**CITY OF SACRAMENTO**  
1231 I Street, Sacramento, CA 95814

**Site Address: 9 SPRINGBROOK CR SAC**  
Parcel No: 030-0121-017

**Nature of Work: FILE REROOF; 32 SQ**

Subject: Structural Investigation Report of the Roof for the Residence located at 9 Springbrook Circle, Sacramento, CA 95831.

**ROOF PLAN - SPHARLER**

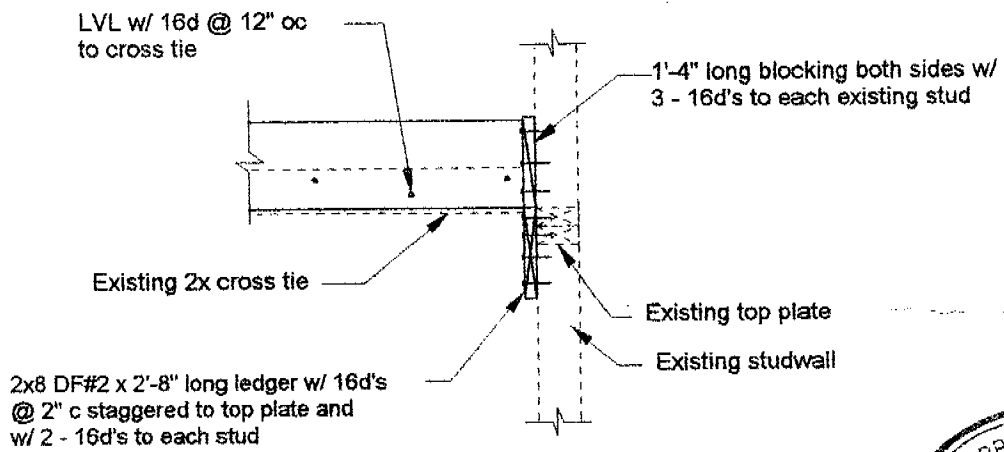
Scab a 1 3/4" x 8 1/2" LVL (B2) to the existing 2x6 cross-tie. Add a 2x4 strut from the valley to the LVL below.
